# 2006 - 2009 Cadillac XLR and XLR-V: Service Bulletin: #PIC4965: Creak Or Ticking Noise From Roof Behind Seats

**Subject:** Creak or Ticking Noise  
From Roof Behind Seats

**Models:** 2006 - 2009 Cadillac  
XLR V and Platinum  
Series

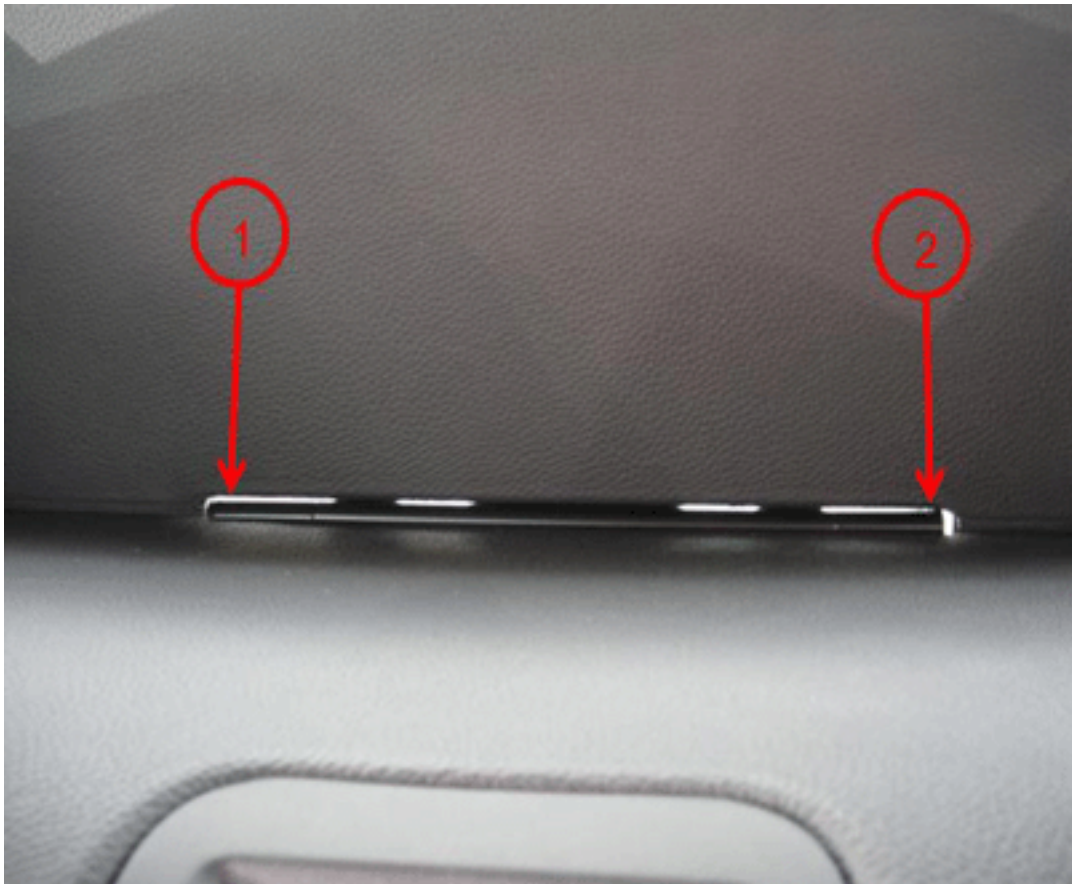
Some customers may comment on a creak or ticking noise heard behind driver while driving with slight road inputs like concrete expansion joints, or loud squawk noise when the front tonneau moves during a power folding roof cycle. This is due to a slip stick condition between the front tonneau cover center panel and the outer portions of the attached hinge. Refer to number 2 in the illustration above.

**Note:** When the tonneau is not adjusted correctly, the contact could occur in call out number 1 or 2 below. However only call out number 2

below demonstrates contact.

To correct this concern, first loosen the middle fastener of the center front tonneau panel hinge. Then loosen the right fastener and move the panel enough to gain 1mm of clearance between the panel and the right outer hinge barrel and re-tighten it to hold that position. Loosen the left fastener and move the panel to gain 1mm clearance between the panel and the left outer hinge barrel and re-tighten the fastener. Tighten the center fastener. When adjusted correctly, the gap for both call outs in the illustration above should look like the gap called out as number 1. Once adjusted, road test or cycle the roof system to verify the repair.
